Public Opinion seems to be the only recourse to getting action from LLTNP

Our ref: snpa17/041 16/07/17

Complaint regarding handling of the camping development at Loch Chon

STORE ROOM / RANGER BASE
END ELEVATION 1:50

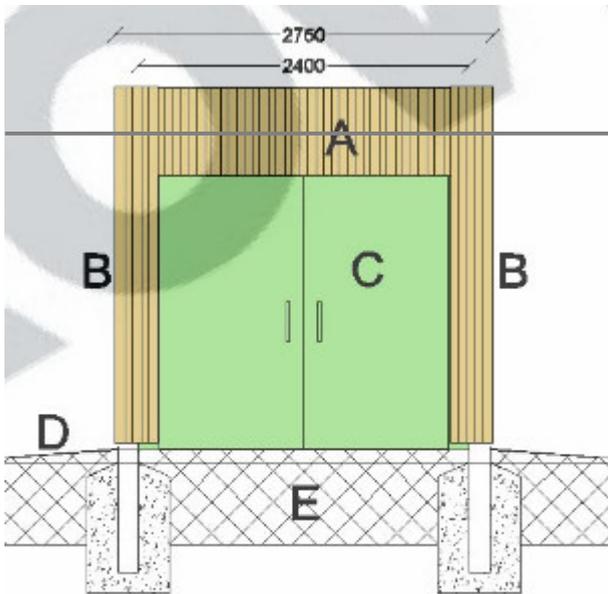
2. The containers used for the Rangers Base and the water purification plant do not correspond with the engineering drawings in respect to the size and finish to the end elevations shown in your documentation.

In both instances the doors fitted are taller than those specified which in turn has prevented fitting a wooden facing above them as specified.

In the case of the Ranger Base Store end the door fitted is larger and of a different design with locking bars on the surface which are totally unsuitable as a solution in this sensitive site.

The wood cladding to the exterior of the containers do not conform to the engineering drawings, the posts and concrete ground supports have not been fitted with the cladding being applied to the container surface directly, this contravenes the design specification and the resultant aspect is an industrial container which has no place in this sensitive area.

Intake Port.

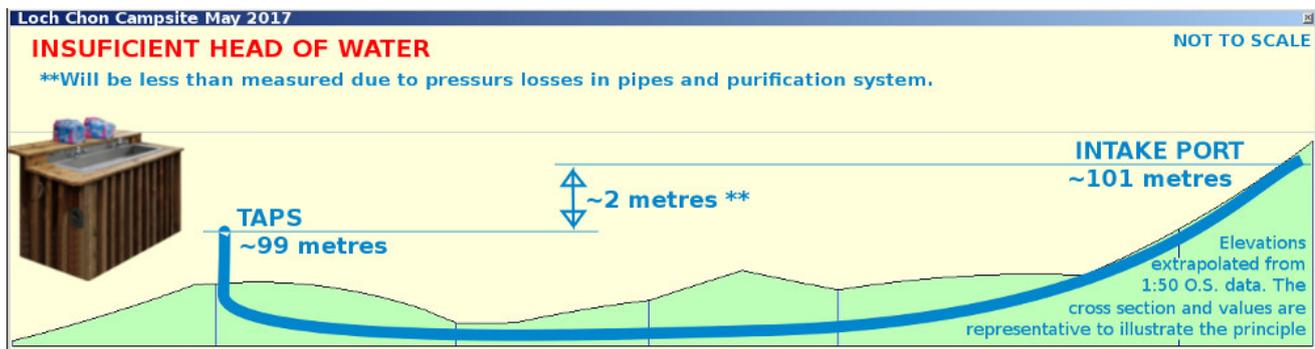
The original drawings which you have removed from your system showed the water intake upstream from its current location as shown here, it is clear that this was the intended position due to pipe clips and small rock built dam.

Due to a failure of the planning department to insist on construction drawings detailing the construction of the necessary reservoir or header tank, or the selection of a suitable natural alternative, to guarantee a sufficient head of water to operate the system, the applicant was not constrained. Their contractor fitted the intake pipe, in good faith, at a location that was later to prove unsuitable as the water level in the stream dropped in dry weather leaving the intake above the water level. This was however the location agreed in the planning consent and it would seem no proper evaluation or calculations of the technical requirements for the intake were carried out to support this location, not least the need to be underwater.

The new location for the intake port is under the cul

vert, I would think a wholly unsuitable location due to it

interfering with the requirement to have a smooth unimpeded surface in the culvert to stop build up of debris.

The resultant head of water has been reduced by a meter or so exacerbating the situation where this reservoir needs to be placed upstream to increase water pressure.
